Havant Thicket Reservoir

Non-Material Amendments to Section 73 Permission – Western and
Embankment and Transition Zone Slope Angles

Report Number: HTR-FUW-P3-RE-RP-W-1716 P01

Figure 2: Approved and Proposed Slope Angles

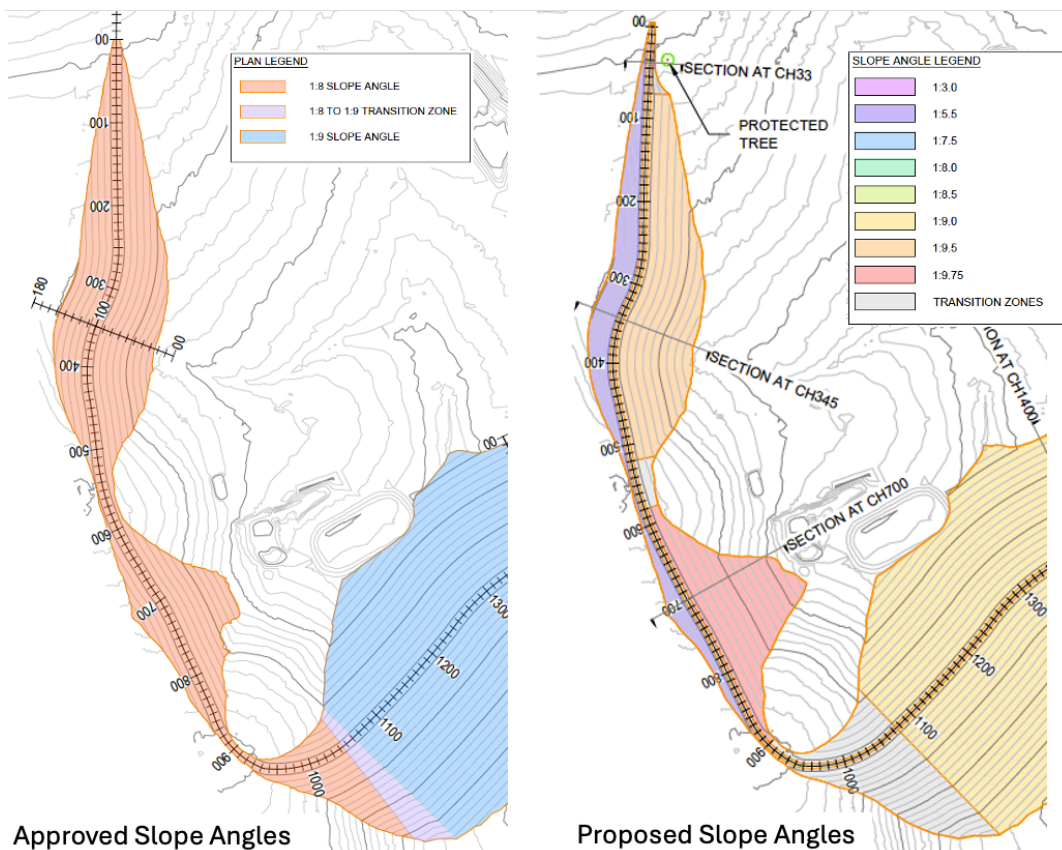
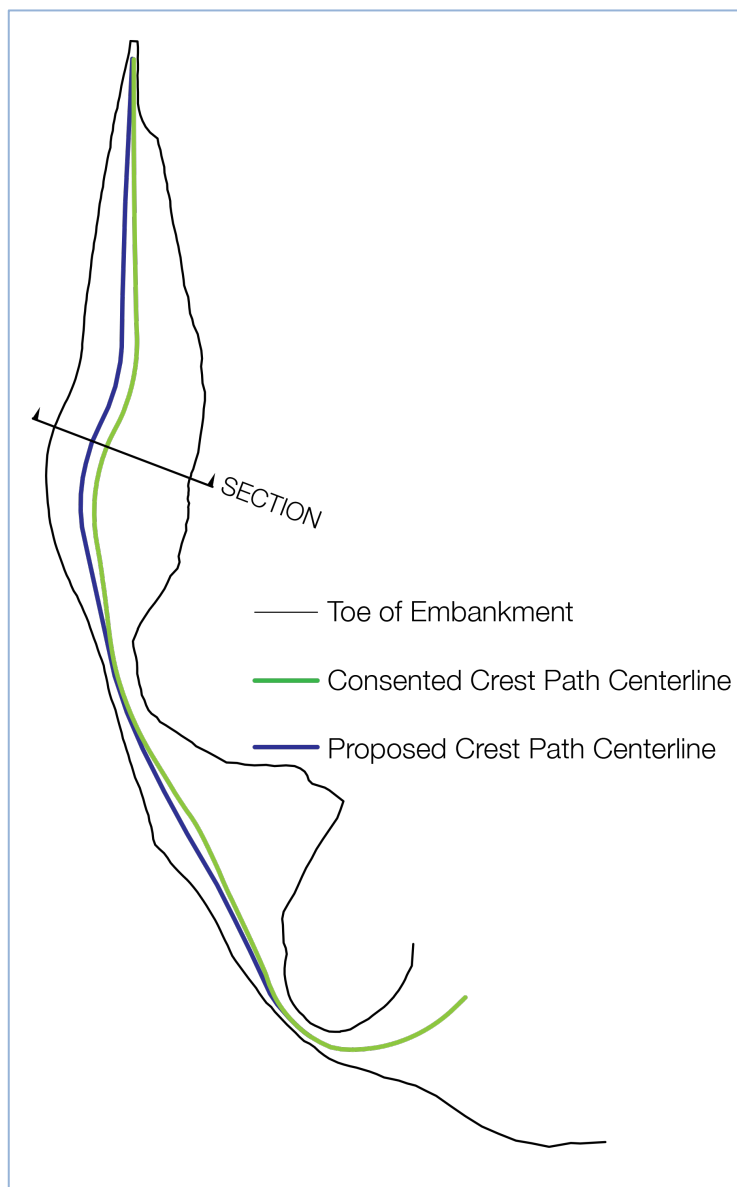
3.5 The proposed NMAs to the slope angles are illustrated in Figure 2 and summarised in Table 1. The amendments will:

- Reduce the angle of the inside slopes of the Western Embankment to remove the structural risk. The amendments will generally be below the water line and therefore not readily visible.

- Increase the angle of the outside slopes of the Western Embankment. There are no changes to the alignment of the outer toe of the embankment or to the height of the embankment. Views of the outside slopes of the Western Embankment are limited and largely screened from the nearest residential properties by existing vegetation which will be maintained and reinforced as part of the landscaping for HTR.

- Alter the Transition Zone from the Western Embankment to tie in with the Main (Southern) Embankment slopes, providing a graded change between the embankments. As a result of these NMAs, there is no change to the Main (Southern) Embankment beyond the Transition Zone.

- Revise the inside slope angles at the northern extent of the Western Embankment to ensure tree G190 located adjacent to the Western Embankment is retained.

Approved	Proposed
Western Embankment Slope and Transition Zone		
Outside slope angles	1:7 to 1:9	1:5.5 to 1:9
Inside slope angles	1:7 to 1:9	1:9. To 1:9.75 Except inside slope chainage up to 70, which will be 1:3 transitioning to 1:9.5 to retain tree G190

Figure 4: Crest Path at Chainage 350

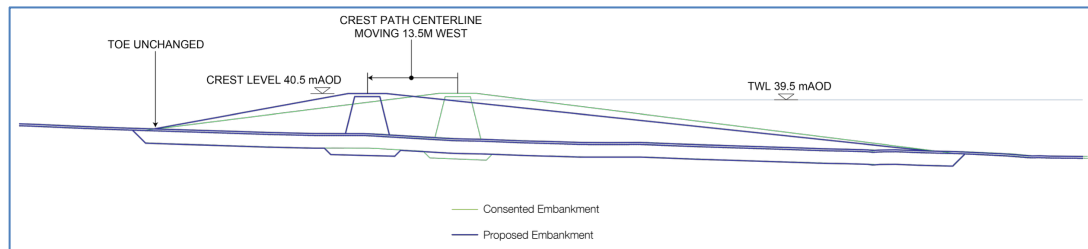
- 3.8 The amendments to the crest path are summarised below:
- Crest path moves 13.5m west at approximately chainage 350 (as illustrated in Figure 4 below).
 - Crest path moves 10.5m west at chainage 700.
- 3.9 This results in a 2m increase in the overall length of the embankment to 2,850m.

- 3.10 The amendments to the realignment of the crest path must be viewed in the context of the reservoir that is over 1600m in width east to west on a site that is over 160 hectares in size. This is a imperceptible amendment when considered in this context and is considered non-material.
- 3.11 It is noted that the length of the crest path length is detailed as 2848m on the approved Section 73 permission plans but Condition 2 on the S73 decision notice was not updated and references the length as 2,800m. It is proposed that the NMA will update Condition 2 to reflect the proposed NMA to 2,850m.
